November 2, 1994

RE: Visual Site Inspection -- Carboline Company
Xenia, Ohio
OHD 030 963 615

FIGURE 2

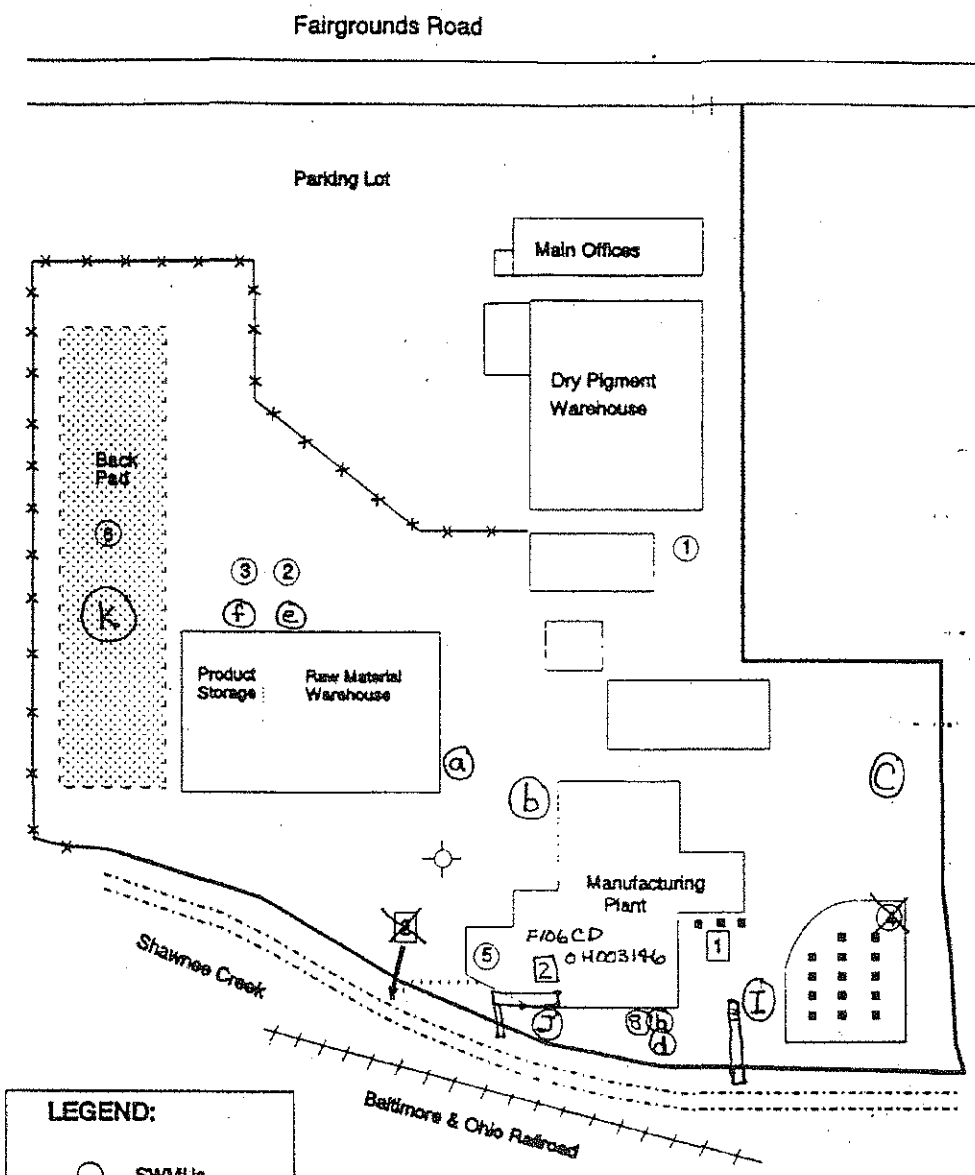
I have enclosed a corrected facility layout diagram, which was Figure 2 on page 5 of the Report. In the diagram that is currently in the Report, the spent solvent tank and the NPDES outfall were incorrectly located. On the enclosed diagram, I have indicated the actual locations of the tank and outfall. I have also added the location of the new containments and some other changes that have occurred at the facility since EPA's visual site inspection (see discussion below).

The first few lines of paragraph 3 on page 7 of the Report are inaccurate. As the thinners become spent, they are pumped into the F-Waste Storage Tank (shown as #4 on the enclosed diagram) and sent off-site to be burned as a supplemental fuel. These spent thinners are ***not*** placed in 55-gallon drums. However, the sludge from the Kettle Washer is transferred to 55-gallon drums which are then emptied into the F-Waste Storage Tank in the Hazardous Waste Storage Area (#4 on the enclosed diagram).

In addition, the outfall covered in Carboline's NPDES permit is non-contact cooling water that is pumped from the well indicated as the "Production Well" in the facility layout diagram (i.e. Figure 2 of the Report) and emitted from a series of settling pits that are part of NPDES permit no. F106*CD-OH0031461.

UPDATES TO FACILITY

a. Containment for tote tank unloading and pumping station

b. Containment for resin tanker unloading

c. Containment for solvent tanker unloading

d. Containment for spent solvent and paint waste loading

e. Decommissioned SWMU #2, hazardous waste storage area

f. Disposed of SWMU #3, D-waste storage tank

g. New contained D-waste storage tank

h. New contained hazardous waste storage area

i. New storm drain with shutoff valve

j. Closed old storm drain

k. Cleared finished goods storage on back pad
